DRB RECOMMENDATION MEETING: JUNE 7, 2018

DESIGN REVIEW

SDCI 3024332 - 4800 40th AVE SW

STEPPING MASSING

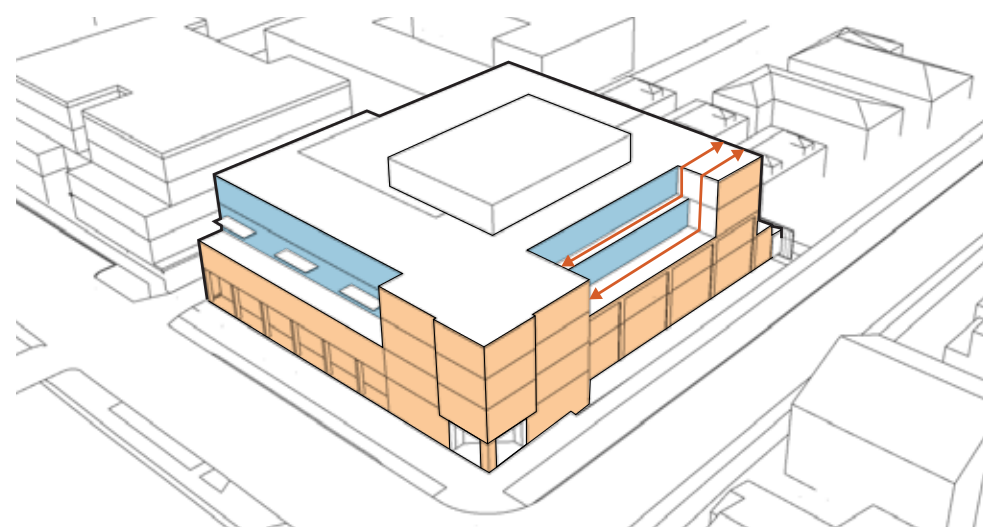
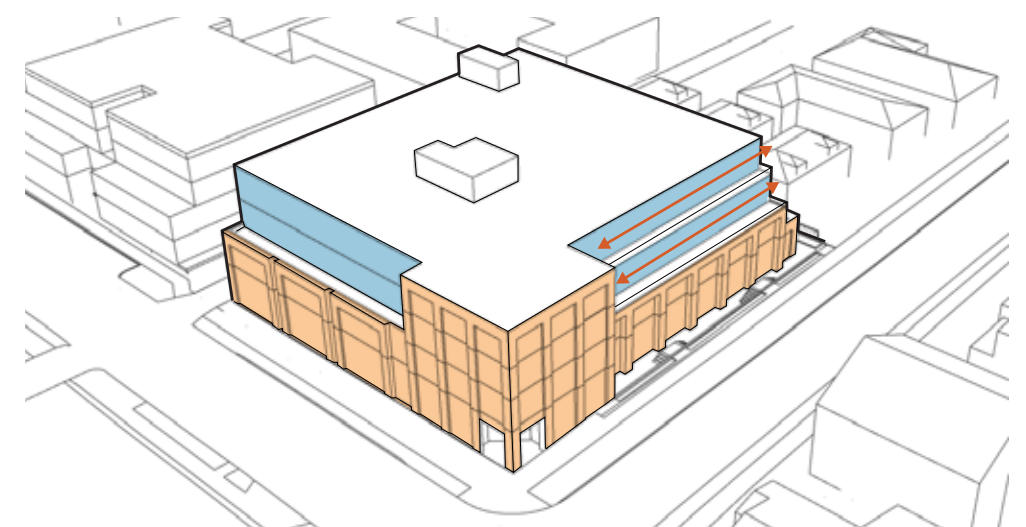
- The overall stepped massing of the building.
- A departure which would allow us to remove some mass from the southern edge of the 40th Ave facade and place it along the alley.

- "In order to reconcile the competing corners and simplify the form", the architect should request a departure to allow us to continue the stepping along 40th all the way to the southern property edge.

We simplified the building form to reinforce the corner as a focal point of the building. The terraces along 40th Ave. SW have been extended to the south facade to further step down the scale along this pedestrian street and ease the massing against the neighboring townhomes. By doing this we are able to establish a gateway point in the transition between the much taller zones north of our site to the smaller, LR zones, to the south. Per the board's recommendation, we have asked for a departure that would allow us to shift the building mass back to the alley.

ZONING DEPARTURE #1

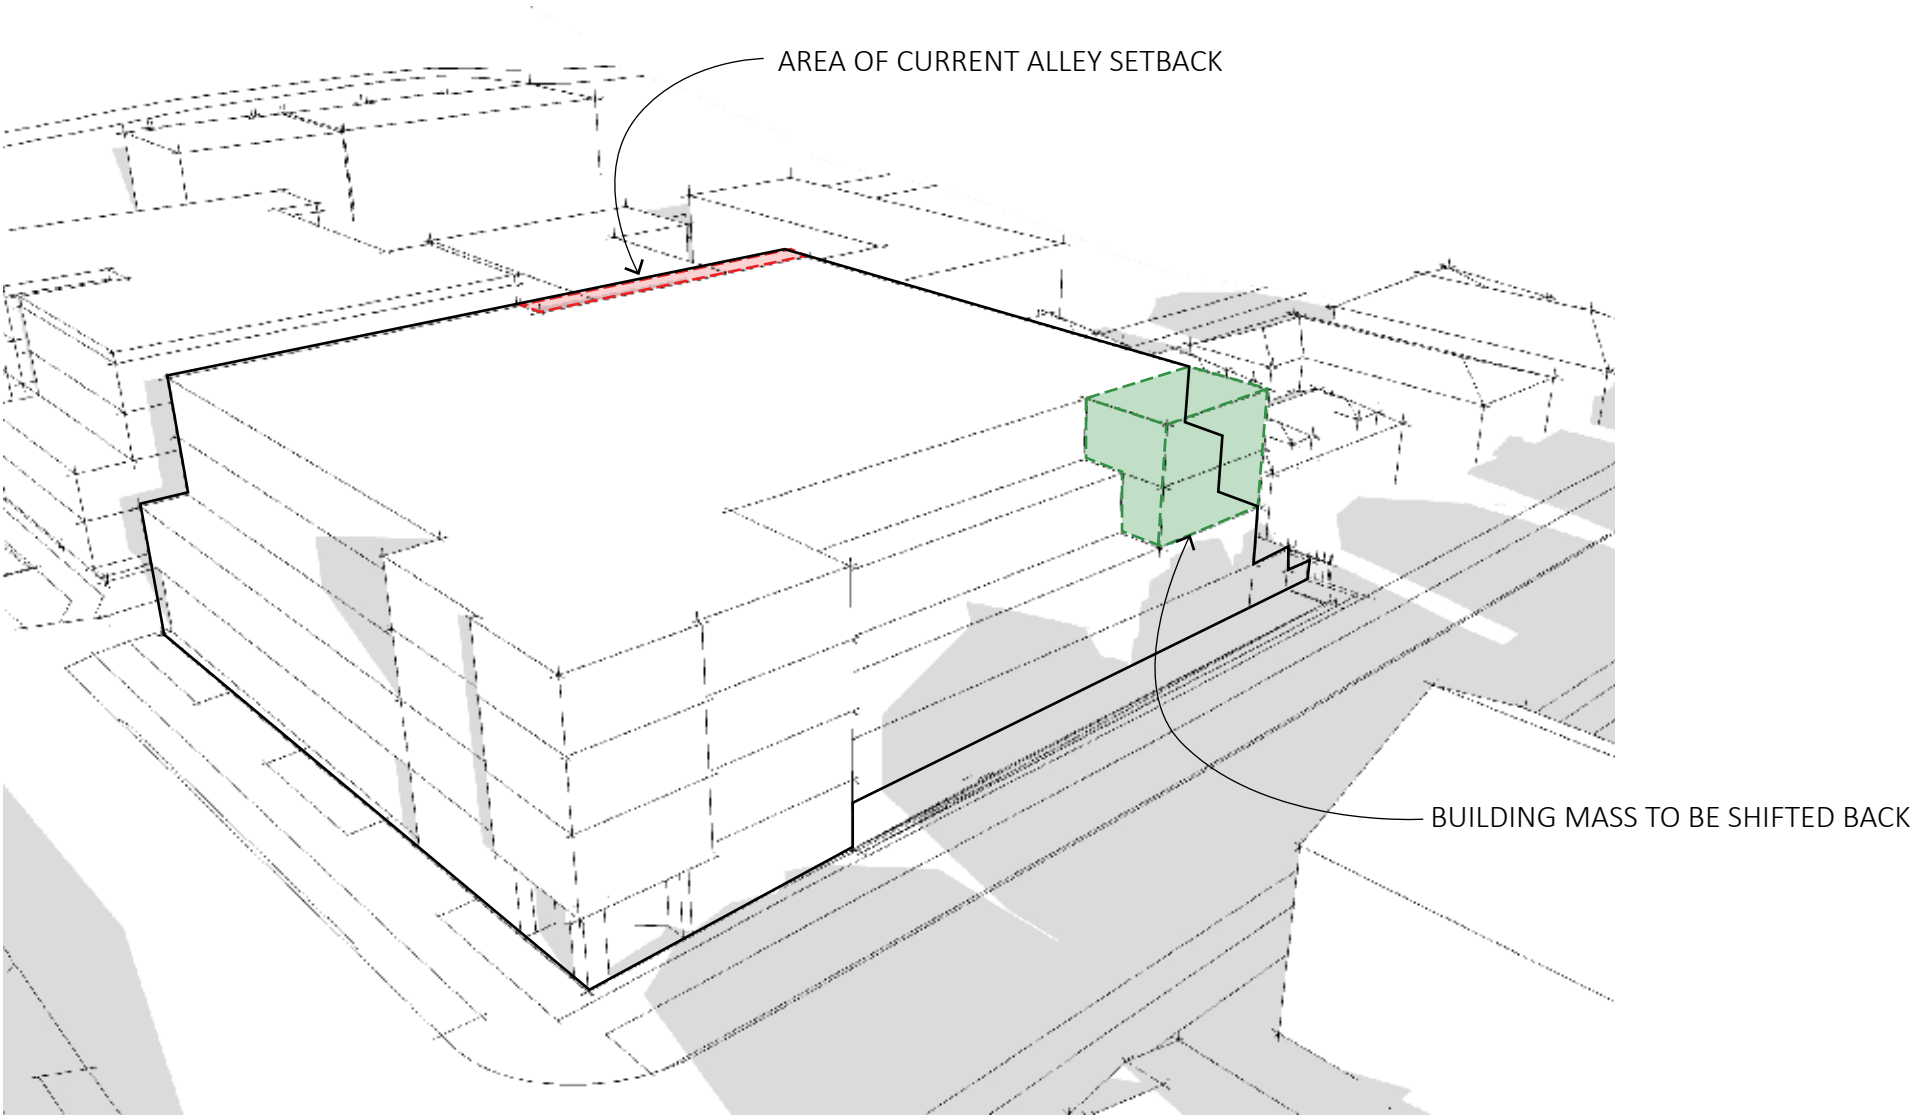
Per Design Review Board recommendation at EDG meeting held 3/16/17, we propose eliminating the required setback on East façade directly adjacent the LR zone.

6.5' feet of side setback along the 75' of south property line that is directly adjacent to the LR zone.

- The shift of building mass to the alley façade from the 40th Ave SW façade allows for the extension of the building terraces to the south.
- The reduced bulk along at the southern edge of our 40th Ave façade steps down the scale to the LR zone to the south.
- The reduced side setback will maintain a constant edge at the alley.

CORNER TREATMENT

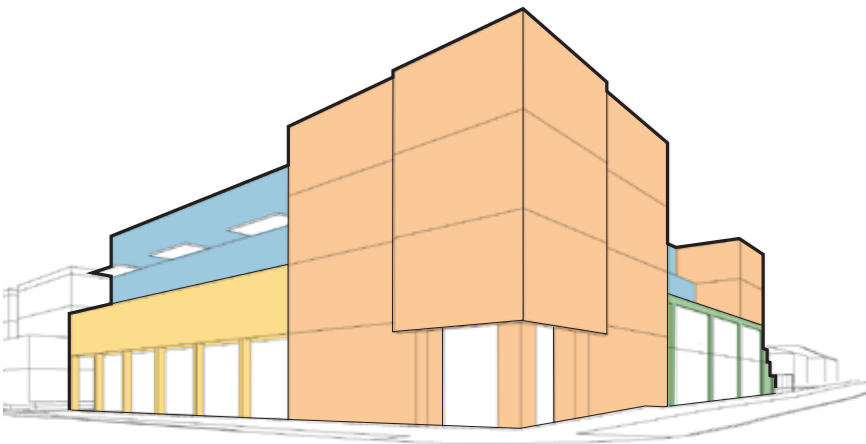
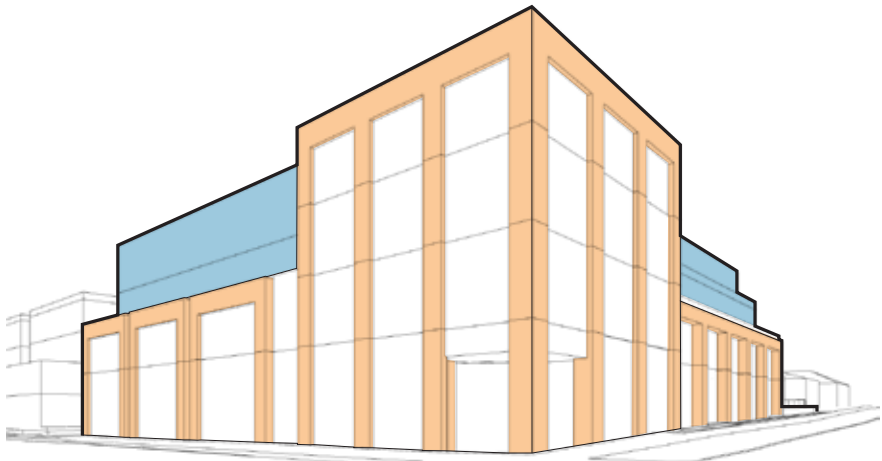
- Further resolution of the building as it turned the corner onto 40th Ave SW.

We have updated both our massing and materiality to create a much more cohesive building. Instead of three, seemingly separate facade treatments we have created a cohesive facade that wraps the two street facades with subtle differences that reflect the use at the street level. Adding the brick to the live work facade aided in not only strengthened and further grounding the public street fronts but also allowed for the upper elements to feel lighter. This change in scale and materiality from the two story block to the lighter upper floors breaks the scale of the project and eases transition from 85'/65' zone north to the LR zone to the south.

FACADE DEPTH AT MASONRY

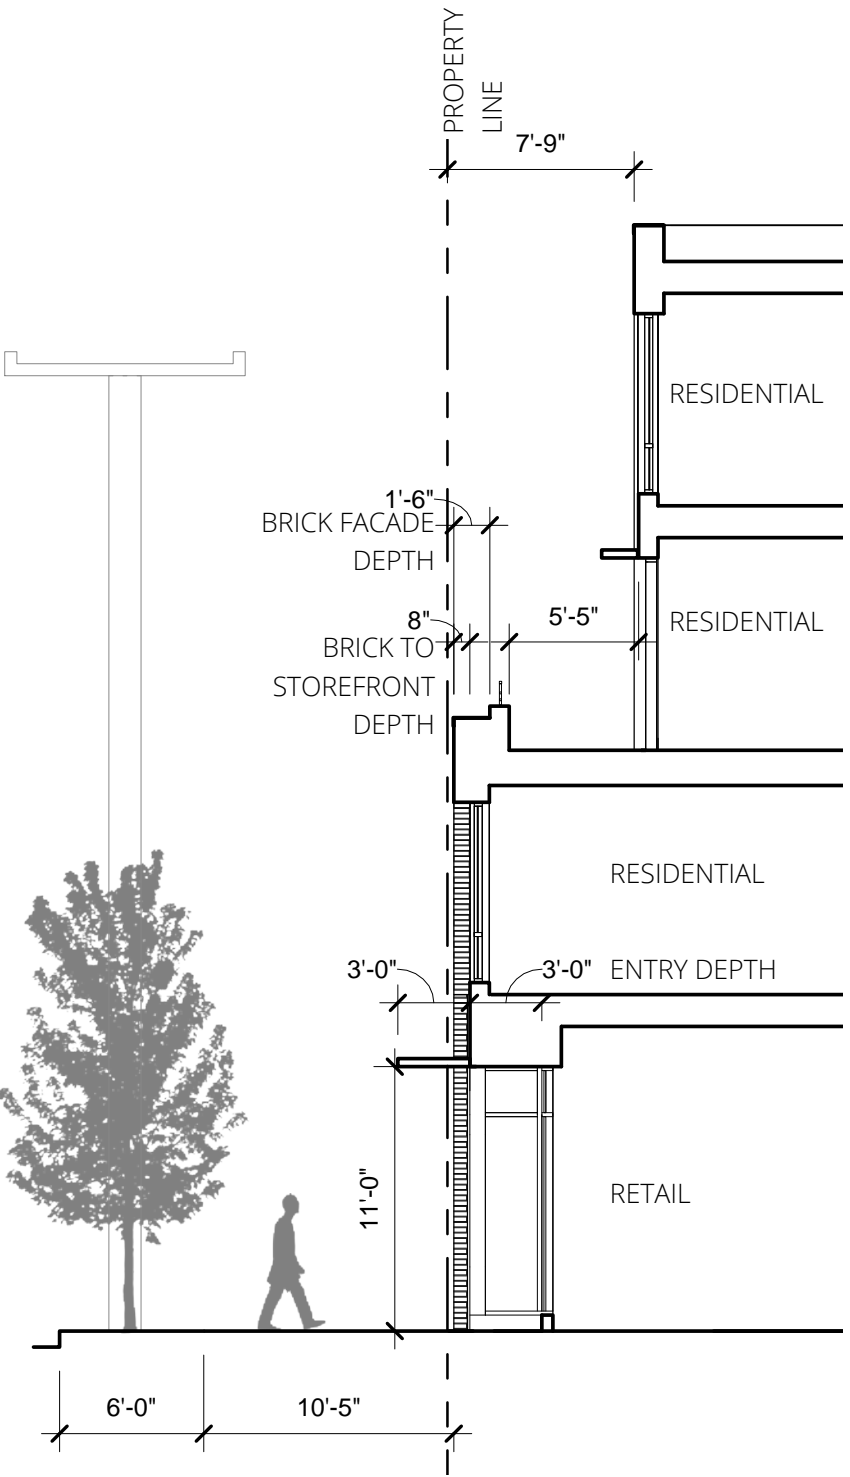
- Reinforcing the strong commercial street frontage
- Enhance pedestrian environment
- Maintain masonry depth that reinforces commercial edge.

Per the board's recommendation, we have further refined our commercial facade articulation to enhance the pedestrian experience. We have maintained the two-story brick facade at both street frontages. The facades have been broken up into more appropriately and humanely scaled bays which echo architectural cues we observed in prominent West Seattle commercial facades. The finely textured brick bays house transparent commercial entries that allow for unencumbered views into the space. These storefront entry bays set into the brick are constructed of metal panel and glass storefront and windows, durable materials for the commercial frontage.

The three commercial entries along Edmunds are recessed off of the sidewalk which has been widened from 7'-0" to 10'-0" to create a more gracious pedestrian pathway and opportunity for the commercial space to utilize some of this outdoor space.

ALLEY CORNER AND SIDEWALK

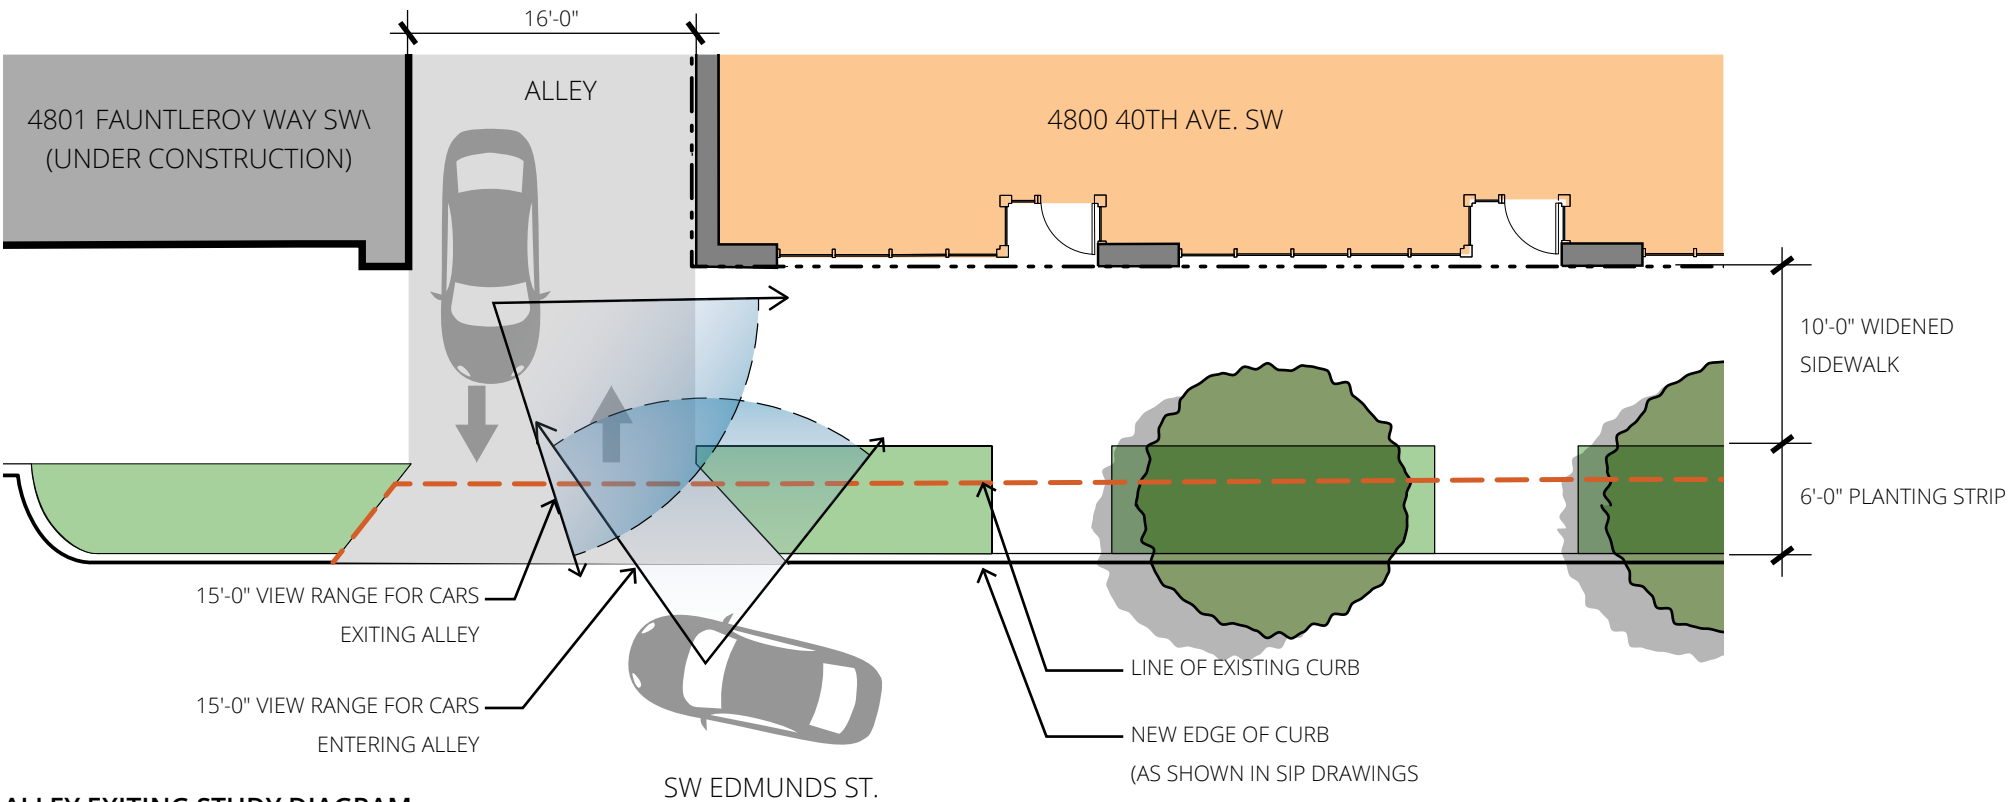
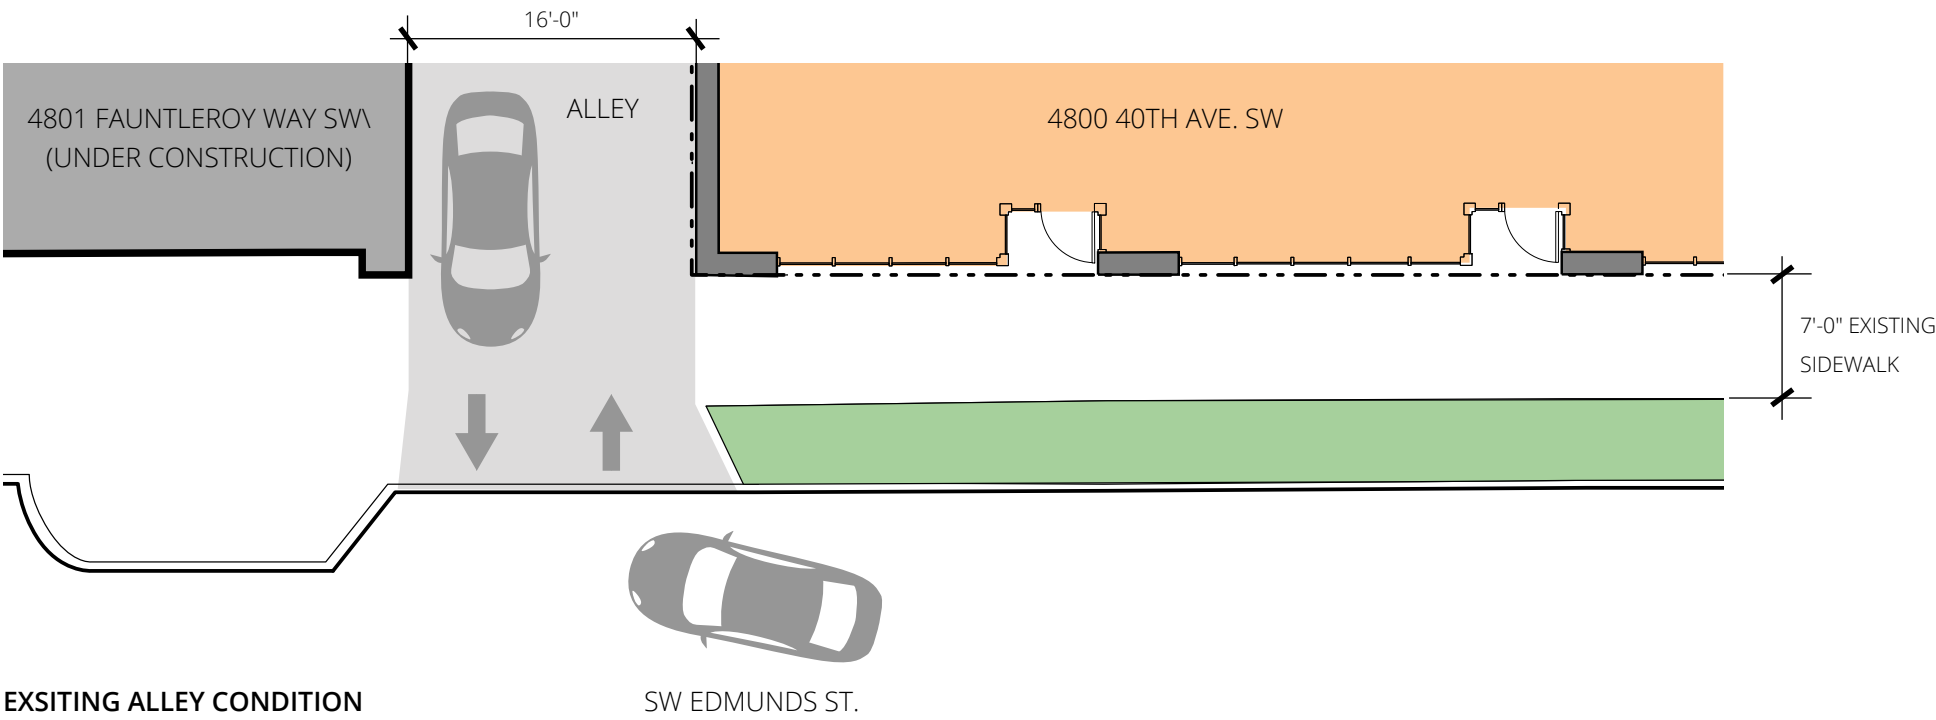
- The study of the alley corner to ensure visibility for vehicles exiting the alley

While we have kept the façade up at the property line to reinforce the board's preferred "strong street edge", we have proposed pushing the sidewalk along Edmunds out to closer align with the street position to the west. This provides a wider physical buffer between the alley corner and the road as well as enhanced visibility for those exiting onto the street. Cars entering the alley, at the west edge, are now given a wider view angle and space to ensure safety of themselves and pedestrians along Edmunds. Cars exiting alley against the adjacent building also have been provided a wider viewing range with respect to pedestrians coming from the west, along our project.

These changes are part of our continued coordination with SDOT.

ZONE TRANSITION

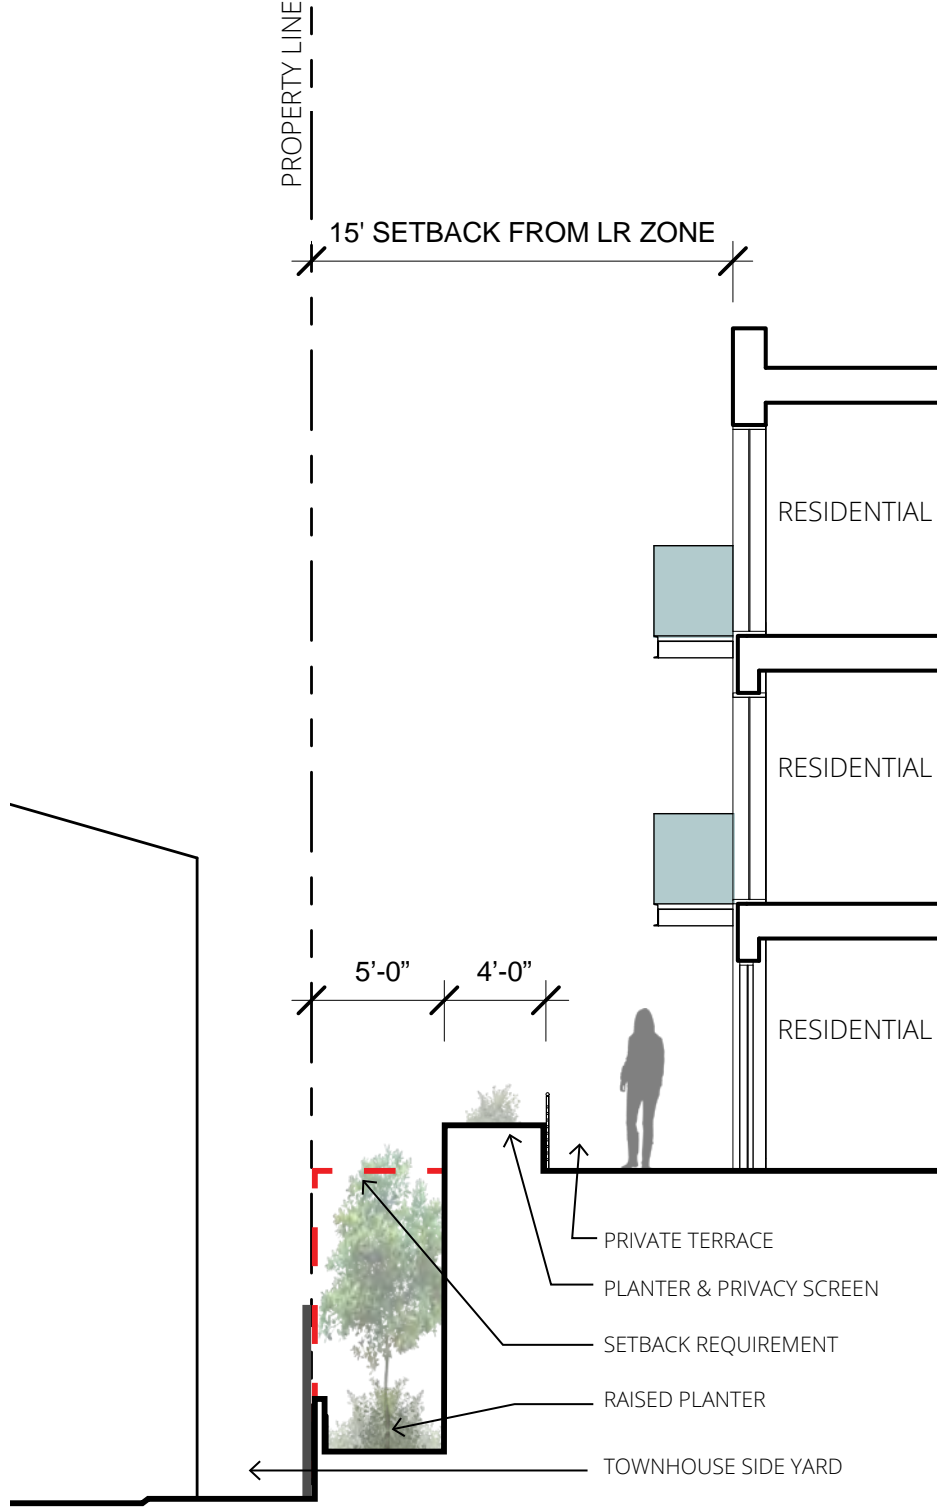
- Study the way the bio retention planter meets the street so as to enhance the pedestrian experience.
- Exploring creating taller greenspace at the zone transition (based on public comments)
- Looking at creating an opaque rail at the edge of the level 2 balcony to create more privacy.

Per the board's guidance, we have kept the 5' bio-retention planter at the southern edge of the property as a buffer between developments. The planter has been designed to meet the property line as a low element and provide a landscape setback between the recessed live work space and the neighbors entry.

Based on public comments and the board's guidance we have designed the planter to step up to between 3' and 4' above grade at the building face to create a slightly taller landscape buffer against the neighboring development's fence line. The planter will step as it extends east toward the alley to maintain a well human-scaled relationship to the adjacent property.

Beyond the planter, we have pulled back the railing on the southern L2 terrace and are proposing planters at the building edge to create even more textured green buffer between our project and the townhomes to the south. This tiered landscape zone will ensure appropriate privacy is maintained.
